IX.A. Final Office Action dated May 12, 2009

APPLICATION NO.	FILING DATE	FIRST NAMED INVENTOR	ATTORNEY DOCKET NO.	CONFIRMATION NO.
09/864,389	05/25/2001	Jacob Richter	2390/49704	1194

# Office Action Summary

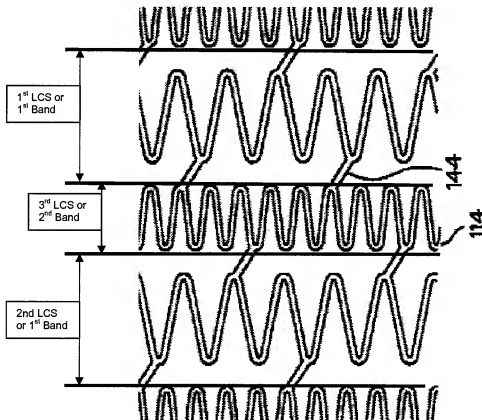
1. Claims 1, 6, 42-47 are rejected under 35 U.S.C. 102(e) as anticipated by or, in the alternative, under 35 U.S.C. 103(a) as obvious over Brown et al-7,204,848.

As to claims 1, 6, 42-47, Brown-'848 (portion of Fig. 2, see below) discloses substantially the claimed invention including following single, continuous, generally sinusoidal loop containing sections or bands: 3<sup>rd</sup> loop containing sections (3<sup>rd</sup> LCS)/2<sup>nd</sup> bands of second frequency F2 **directly joined** 1<sup>st</sup> loop containing sections (1<sup>st</sup> LCS)/1<sup>st</sup> bands of 1<sup>st</sup> frequency F1 and 2<sup>nd</sup> loop containing sections (2<sup>nd</sup> LCS)/1<sup>st</sup> bands of 1<sup>st</sup> frequency F1 (F1< F2) as recited in the claims.

Further, Brown-'848's Fig. 2 clearly shows 1<sup>st</sup> and 2<sup>nd</sup> loop containing sections/1<sup>st</sup> bands including members 144 circumferentially wider than members 120 of 3<sup>rd</sup> loop containing section/ 2<sup>nd</sup> bands as recited in the claims. All generally sinusoidal loop containing sections or bands are single because they have single members, such as members 120 or 144.

Alternatively, it would have been obvious to one of ordinary skill in the art to provide wider members 144 of 1<sup>st</sup> and 2<sup>nd</sup> loop containing sections in comparison to narrower members 120 of 3<sup>rd</sup> loop containing section to provide more strength for at locations of 1<sup>st</sup> and 2<sup>nd</sup> loop containing sections as one desires. Further, It would have been an obvious matter of design choice to modify the size of members 144 to be wider than members 120, since such a modification would have involved a mere change in the size of a component. A change in size is generally recognized as being within the level of ordinary skill in the art. In re Rose, 105 USPQ 237 (CCPA 1955).

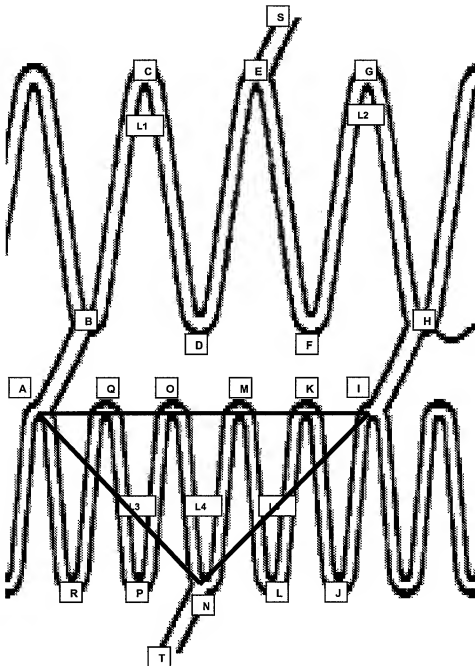
2. Claims 11 and 26 are rejected under 35 U.S.C. 102(e) as anticipated by or, in the alternative, under 35 U.S.C. 103(a) as obvious over Brown et al-7,204,848.

As to claim 11, Brown-'848 (portion of Fig. 2, see below) discloses substantially the claimed invention including triangular cells including following single, continuous, generally sinusoidal loop containing sections: 3<sup>rd</sup> loop containing sections ABCDEFGHI of second frequency F2 joining 1<sup>st</sup> loop containing sections ARQPON of 1<sup>st</sup> frequency F1> F2 and 2<sup>nd</sup> loop containing sections NMLKJI of frequency F1>F2, 1<sup>st</sup> loop containing sections. Brown-'848's Fig. 2 shows members 144 of 3<sup>rd</sup> loop containing section including wider members 144 than members 120 of 1<sup>st</sup> and 2<sup>nd</sup> loop containing sections as recited in the claims. All generally sinusoidal loop containing sections or bands are single because they have single members, such as members 120 or 144.

Alternatively, it would have been obvious to one of ordinary skill in the art to provide wider members 144 of 3<sup>rd</sup> loop containing sections in comparison to narrower members 120 of 1<sup>st</sup> and 2<sup>nd</sup> loop containing sections to provide more strength for at locations of 1<sup>st</sup> and 2<sup>nd</sup> loop containing sections as one desires. Further, It would have been an obvious matter of design choice to modify the size of members 144 to be wider than members 120, since such a modification would have involved a mere change in the size of a component. A change in size is generally recognized as being within the level of ordinary skill in the art. In re Rose, 105 USPQ 237 (CCPA 1955).

As to claim 26, Brown-'848's Fig. 2 and Fig. 3 show a stent of stainless steel or Nitinol (C. 12, ll. 25-37 and enlarged one cell below) including triangular cells having wider and stronger members of lower frequency F1 (1<sup>st</sup> member ABC, 2<sup>nd</sup> member CDE, 3<sup>rd</sup> member EFG, 4<sup>th</sup> member GHI) than members of higher frequency F2 (5<sup>th</sup> member ARQP, 6<sup>th</sup> member PO, 7<sup>th</sup> member ON, 8<sup>th</sup> member NM, 9<sup>th</sup> member ML and 10<sup>th</sup> member LKJI) and 1<sup>st</sup> to 10<sup>th</sup> members formed 1<sup>st</sup> loop L1, 2<sup>nd</sup> loop L2, 3<sup>rd</sup> loop L3, 4<sup>th</sup> loop L4 and 5<sup>th</sup> loop L5 substantially as recited in the claims.

Alternatively, it would have been obvious to one of ordinary skill in the art to provide wider 1<sup>st</sup>, 2<sup>nd</sup>, 3<sup>rd</sup>, 4<sup>th</sup> members of lower frequency in comparison to narrower members 120 of 6<sup>th</sup>, 7<sup>th</sup>, 8<sup>th</sup>, 9<sup>th</sup> and 10<sup>th</sup> members to provide more radial strength at locations of 1<sup>st</sup>, 2<sup>nd</sup>, 3<sup>rd</sup>, 4<sup>th</sup> members of lower frequency and narrower members 120 of 6<sup>th</sup>, 7<sup>th</sup>, 8<sup>th</sup>, 9<sup>th</sup> and 10<sup>th</sup> members to provide more flexibility for the stent to adapt to curvatures of a curved blood vessel. Further, it would have been an obvious matter of design choice to modify the size of members 144 to be wider than members 120, since such a modification would have involved a mere change in the size of a component. A change in size is generally recognized as being within the level of ordinary skill in the art. In re Rose, 105 USPQ 237 (CCPA 1955).
